Service Bulletin

Bulletin No.: PIP5009F

Subject: Replace the Internal Transmission Wiring Harness and TCC Enable Solenoid Anytime the Transmission is in for Service - Malfunction Indicator Lamp (MIL) With DTC P0741 Set and Harsh 1-2 shift Vehicles manufactured after 10/01/11

Models: 2012 Chevrolet Colorado, Express, Silverado
2012 GMC Canyon, Savana, Sierra
All Equipped with Automatic Transmission 4L60E (RPO M30). Built after 10/01/11

2854421

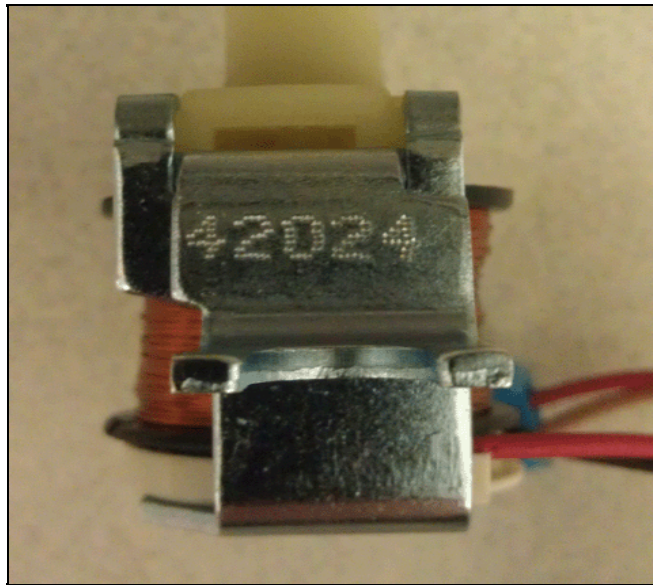
Note: To prevent multiple TCC Enable Solenoid and Wire Harness replacements check the five digit date code on the TCC Enable Solenoid body to see if it has been replaced.

The first digit (month of build) should be a 4 or higher or an alpha character. The second and third digits are the day of the month. The fourth digit should be a 2 or 3 (calendar year 2012, 2013).

The fifth digit (line of build) should be a numeric character typically a 3 or 4 Example: 42024 shown in the picture below was produced April 20, 2012 on line 4.

Any solenoid produced on or after April 4, 2012 date code of 4042# or greater does not need to be replaced.

Important: Replace the TCC Enable Solenoid and Wire Harness part number 24237980 anytime repairs are being performed on the transmission on vehicles manufactured after 10/01/11.
